Town of West Yellowstone

Town Council Work Session

Moonrise Meadows Subdivision

**STAFF REPORT
MOONRISE MEADOWS MINOR SUBDIVISION
PRELIMINARY PLAT APPLICATION**

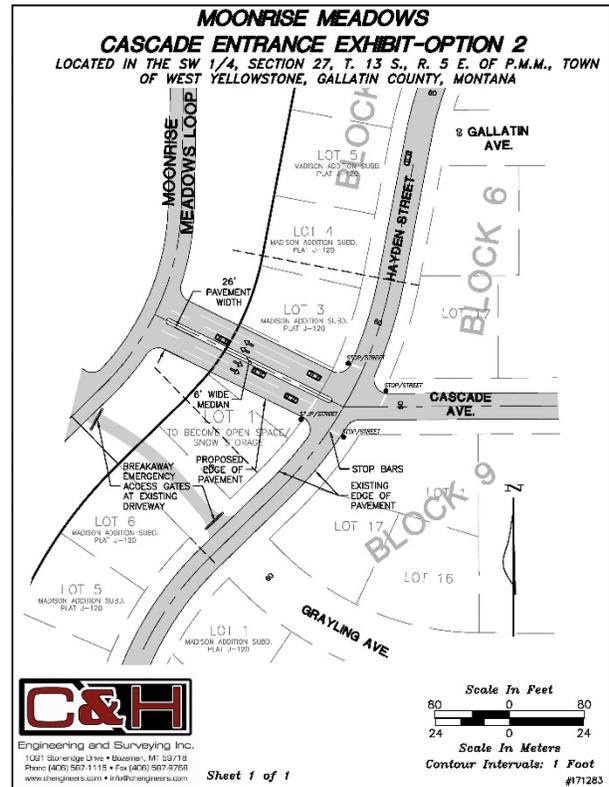
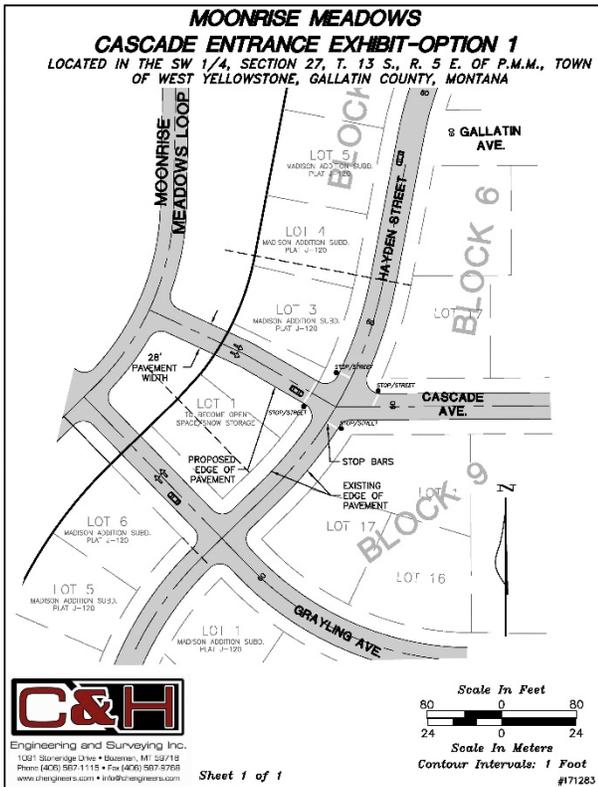
While the subdivider’s agent addressed this from the perspective of fire safety, it is not clear whether Chief Newell’s concern with the single ingress/egress is alleviated in full. The International Fire Code’s provisions are noteworthy in terms of fire-related access issues, and the proposed wider 36-foot road width at the subdivision entrance is an important consideration. Part of the justification provided for having only one ingress/egress under the International Fire Code is that all buildings “are equipped throughout with an approved automatic sprinkler system”. At this time it is not clear whether the existing home and garage with apartment are equipped with such systems, but the subdivider has indicated retrofitting can occur if necessary.

As Chief Newell wrote, if for some reason Grayling Avenue within the subdivision were to become blocked, there is no other way in or out of the subdivision. If this happened under dangerous circumstances like a wildland fire, the results could be disastrous.

During the public hearing the reviewing planner, Planning Advisory Board members, and members of the public expressed that only having one access to the subdivision is a safety concern. Based on this concern the subdivider proposed two new options for access to the property (Figures 4 and 5 below). Option 1 would include two accesses, one aligned with Grayling Avenue and one aligned with Cascade Avenue. Both accesses would be 28 feet wide one-way streets. Option 2 would provide a primary and an emergency access, with the primary access four lanes (52 feet) wide with an additional six-foot drive-over median, and using the existing Moonrise Way as an emergency access with break-away gates. The Planning Advisory Board chose to recommend that the subdivider provide two ingresses/egresses built to Town standards and be approved by the Town's Engineer instead of choosing a specific option.
